Access Compliance Report Public Rights-of-Way (Curb Ramps)

Main Street: SKYWOOD_ST Cross Street: SIENNA_PKWY Location: W

ADA ID: RPRK211021142208 Ramp Type: Type 1 - Perpendicular Diagonal Initial Pass/Fail: Pass Overall Compliance: No Severity Score: 21

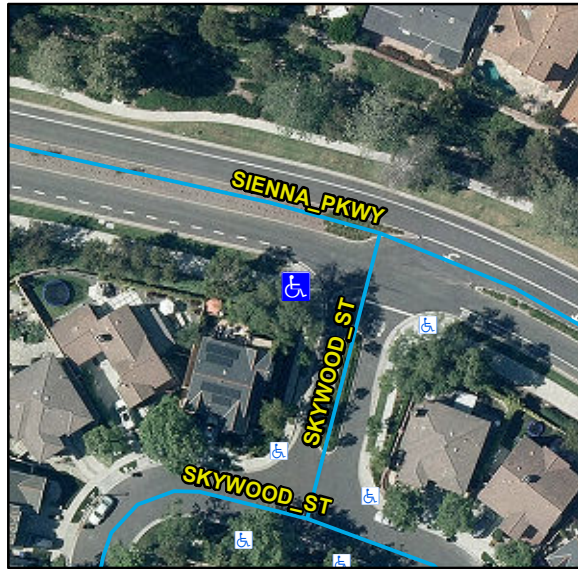
Compliance	Description	Data	Compliance	Description	Data
N/A	Ramp Length (in)	158	N/A	Flare Type LT	
Yes	Ramp Width (in)	48			Sloped
Yes	Ramp Run Slope (%)	5.1	N/A	Flare Slope LT (%)	10.1
Yes	Ramp Cross Slope (%)	0.9	N/A	Flare Traversable LT	No
N/A	Landing Present	Yes	N/A	Flare Type RT	
N/A	Landing Length (in)	33			Sloped
Yes	Landing Width (in)	48	N/A	Flare Slope RT (%)	5
Yes	Landing Run Slope (%)	0.9	N/A	Flare Traversable RT	No
Yes	Landing Cross Slope (%)	1.7	No	DWS Provided	No
N/A	Landing Movement Obstructed?	No	N/A	DWS Contrast	N/A
	Landing Movement Type	N/A	N/A	DWS Length (in)	N/A
N/A	Landing Shared	No	N/A	DWS Full Width	N/A
N/A	Clear Space	Yes	N/A	DWS Offset Left (in)	N/A
N/A	Clear Space To Crosswalk (in)	48	N/A	DWS Offset Right (in)	N/A
N/A	Marked Crosswalk 1	No	N/A	Marked Crosswalk 2	No
	Crossing 1 Direction	SE		Crossing 2 Direction	NE
	Marked Crosswalk 1 Width (in)	N/A		Marked Crosswalk 2 Width (in)	N/A

N/A	Ramp Inside Crosswalk 1	N/A	Yes	Ramp Inside Crosswalk 2	N/A
	Crossing 1 Slope (%)	2.9		Crossing 2 Slope (%)	3.4
	Crossing 1 Cross Slope (%)	1.8		Crossing 2 Cross Slope (%)	2.1
Yes	Gutter Ponding	No	Yes	Curb Slope	5
Yes	Gutter Lip Height (in)	0		Road Run Slope (%)	1.7
No	Gutter Run Slope (%)	9		Road Cross Slope (%)	5.8
Yes	Gutter Cross Slope (%)	1.6			
Yes	Overall Surface Condition: Acceptable		No	Perp Joint Present	No
	Cross Gutter Present?	No		Spandrel Present?	No
	Replace Cross Gutter?	N/A		Replace Spandrel?	N/A

Remove & Replace Curb Ramp With Two New Directional Ramps or Equivalent. Remove & Replace Gutter.
